# **DESIGN REVIEW RECOMMENDATION MEETING**

**June 5, 2017**

DPD # 3022416  
1443 NW 63rd St  
Seattle, WA 98107

VIEW OF FRONT AMENITY AREA

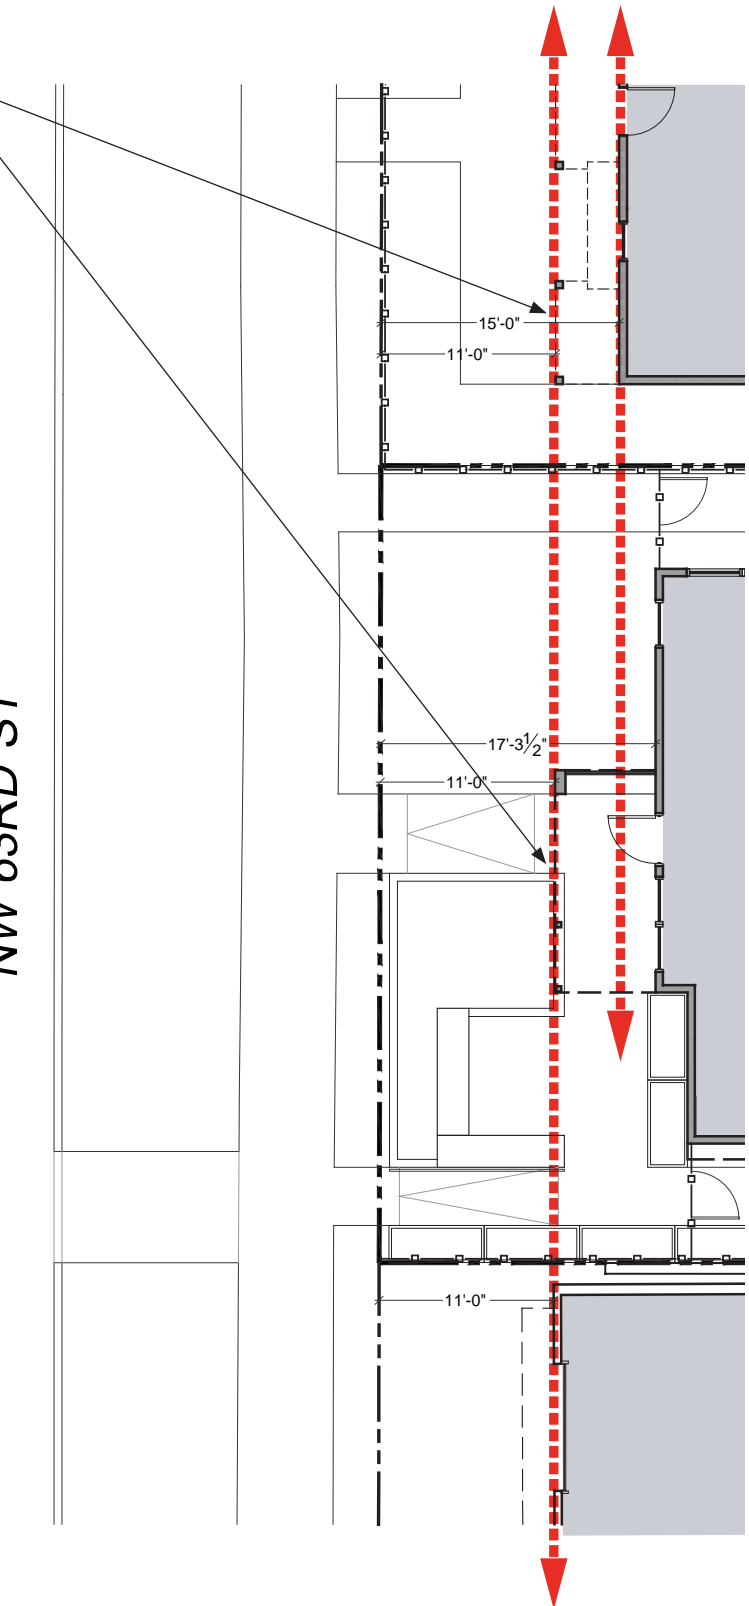
The board echoed the concerns of the public and encouraged the applicant to match the front setback to that of buildings along the street.

The existing multifamily buildings along NW 63rd St follow a consistent 15' front setback with secondary modulations that extend up to 11' from the property line. The proposed structure is shifted back on the site to preserve the appearance of this strong street edge.

The proposed central modulation is located 11'-2" from the property line - aligning with the balcony projection of the townhomes to the East. The rest of the facade has a setback of 17'-3" visually aligning with the primary mass of the East townhomes. Shifting the building back does cause the rear yard setback to decrease to 11'-1" from the minimum 15' setback required for apartments in LR zones (see page 38 for proposed departure).

The larger front yard allows for an amenity area between the building entrance and the sidewalk. East of the entry is a rain garden covered in dense plantings and to the West is a small seating area with built-in benches and planters. The amenity area creates a buffer between the public sidewalk and the apartment units.

ROOF PLAN  
NTS

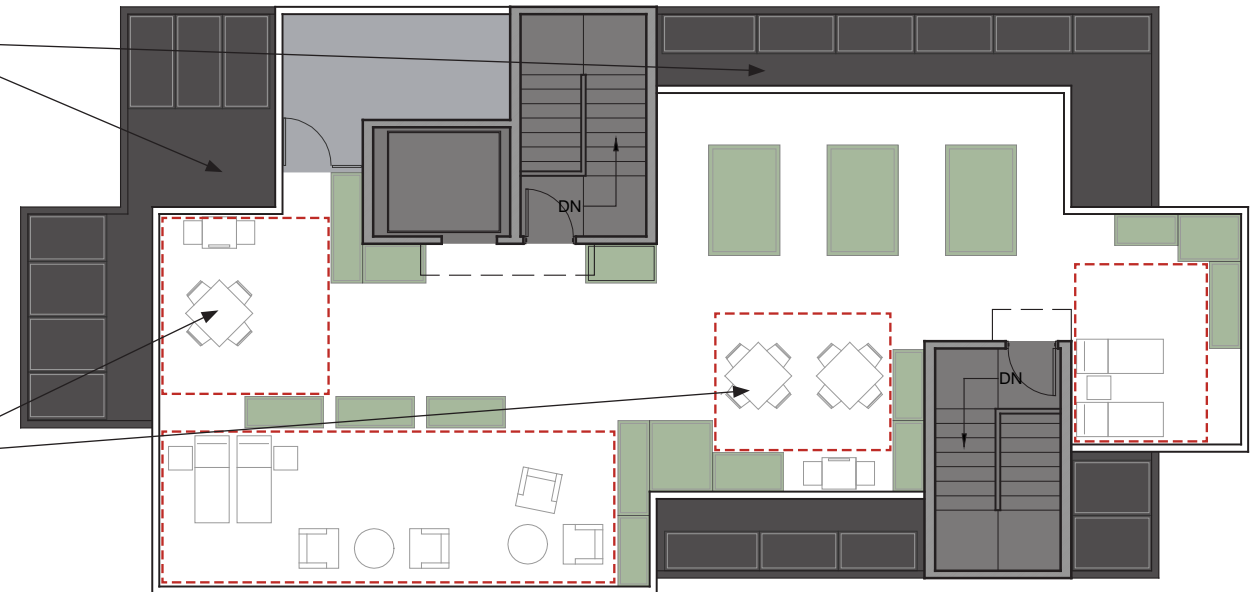
The board suggested that the applicant should shrink the rooftop amenity space to mitigate privacy impacts on nearby residences.

The rooftop deck has been reduced and shifted away from exterior walls adjacent to neighboring buildings. The original proposed roof deck was around 1750 sf and has now been decreased to 1435 sf.

Where the parapet is set back from the exterior walls, planters containing a mixture of grasses and low shrubs are used as a buffer to screen direct views to neighboring properties and to dampen sound coming from the roof deck.

Small, intimate seating areas are defined by arrangements of planters discouraging large gatherings toward the East and South to reduce privacy impacts on townhomes. The two barbeque areas are located toward the North and West, orienting the potentially louder activities toward the commercial zoning and away from neighboring residences.

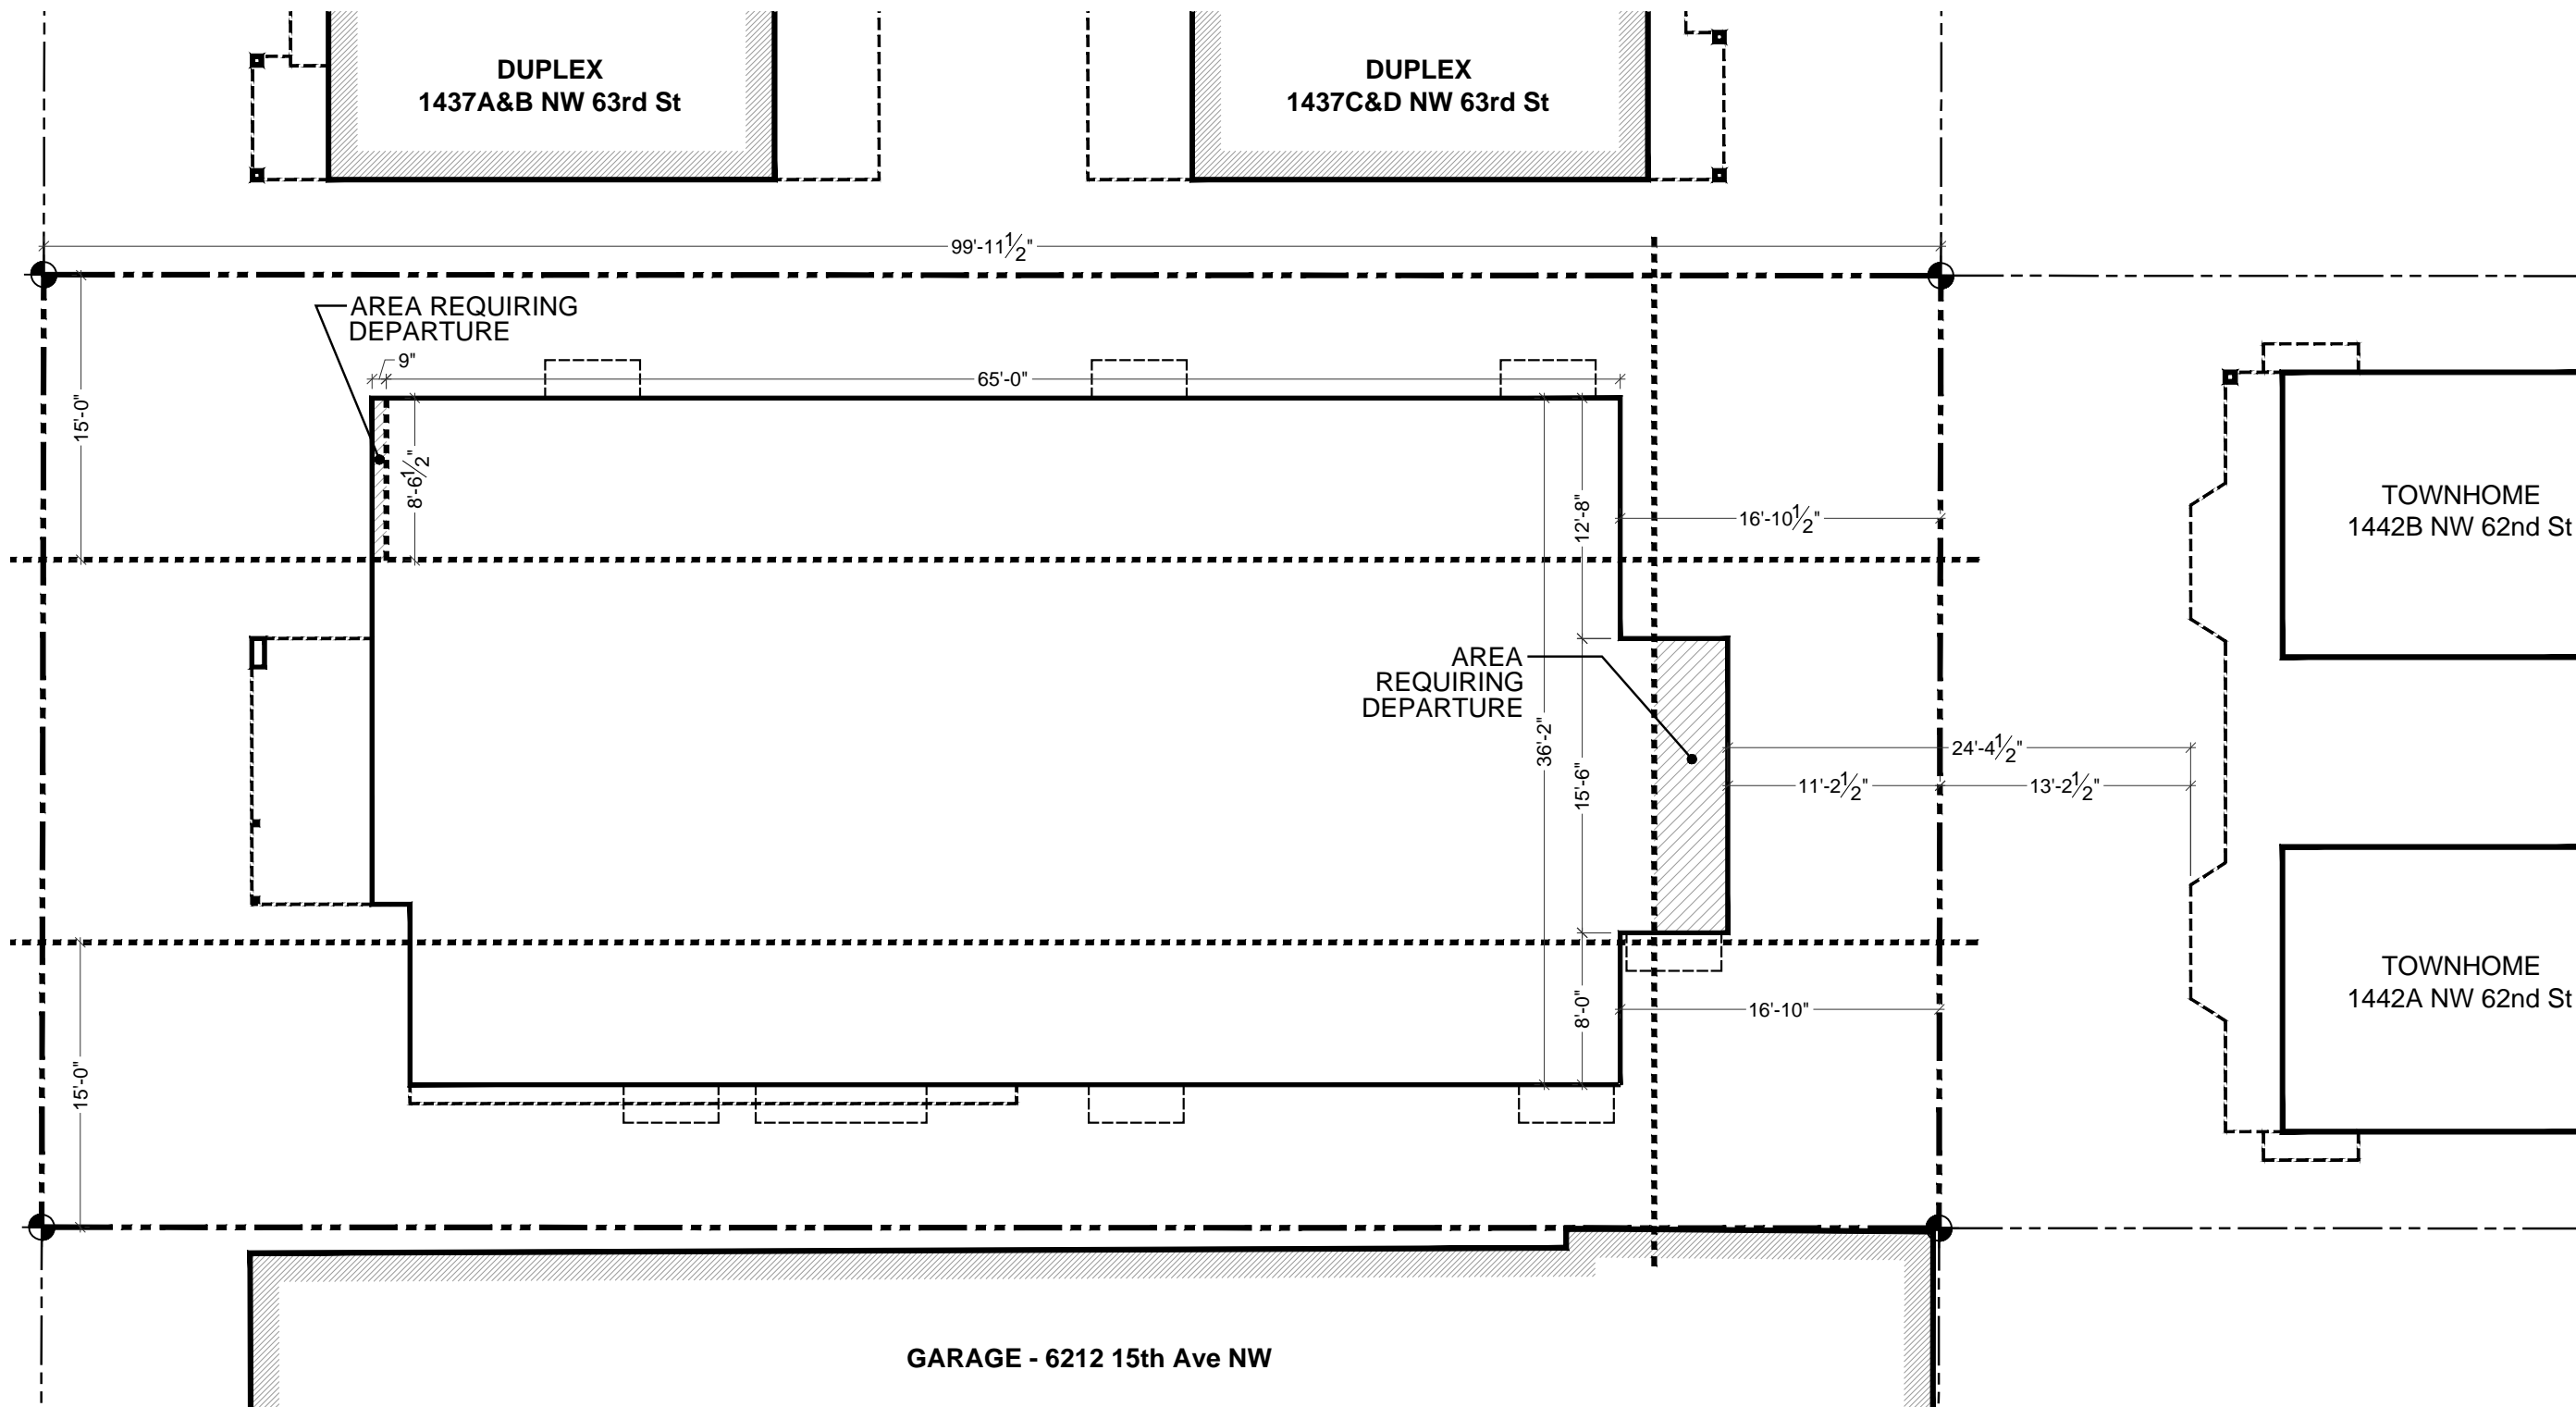
The board recommended the use of high-quality materials that will weather well, especially if a lighter color such as white is used.

The primary materials are Fiber Cement Board painted light gray and horizontal lap siding painted a dark, warm gray. Both of these materials have been shown to withstand the Seattle climate well and the darker colors were chosen in response to the public's concern at the EDG meeting of light colors potentially not weathering well in Seattle.

The secondary materials are Fiber Cement Board painted white and vertical cedar siding with a clear stain. These secondary colors were chosen to reflect material choices on the adjacent townhomes. The townhomes directly to the East have a primary burgandy paint with white trim detailing and an accent of cedar on the balcony. The proposed material palette takes a modern approach to this palette - white is used to define window sets and the cedar is used to articulate specific parts of the structure including the front entry and both stair towers.

The mixture of Fiber Cement Board panels, horizontal lap siding and vertical cedar create a composition of varying scales and depths of material along the facade.
